Aftermarket News (May'18)

2. Product and Packaging Box Design Change

Spark Plug - Iridium Series

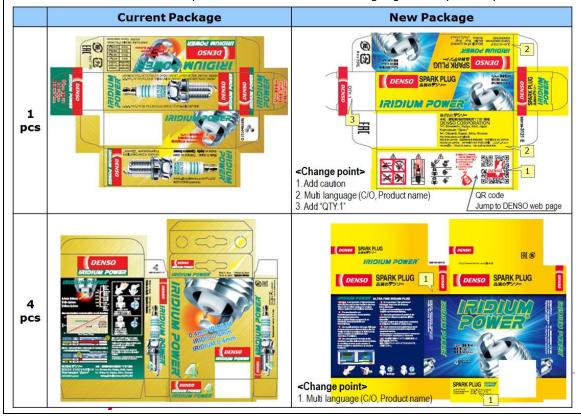
To improve production efficiency and therefore to increase production capacity, the appearances of IR Power series is changed from Feb'18 production onwards.

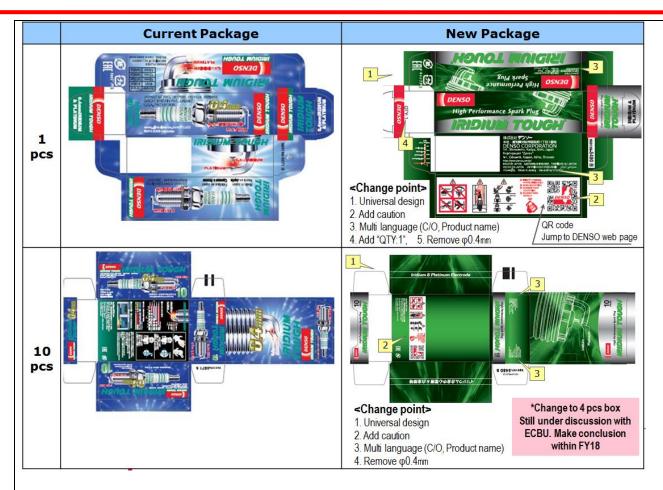
Two changing points are considered as below:

Change point	Purpose	Product		Current SPEC		\Rightarrow	New SPEC		Negative impact for performance
	Remove				3 lines (193 PNs)	2		Remove 3 lines as same as OE	1	None
1)	3 lines on insulator	efficiency	IR Tough IR Racing		No line (4 PNs)	types	D/ASO MIDIUM TOUGH	(197 PNs)	type	*Appearance change only
		Improve		*F				Phase out "Gold nut", then change to "Silver" or "Solid"		
2	Reduce types of terminal nut	production efficiency, and installation	IR Power IR Tough IR Racing	*Removable		3 types		Applied only for 2W & Old application (60 PNs *Removable)	2 types	None *Refer to below for details
		reliability	tallation		Iron nut *Solid (65 PNs)		F	Most of PNs will be changed to "Solid" as same as OE (137 PNs)		a stans
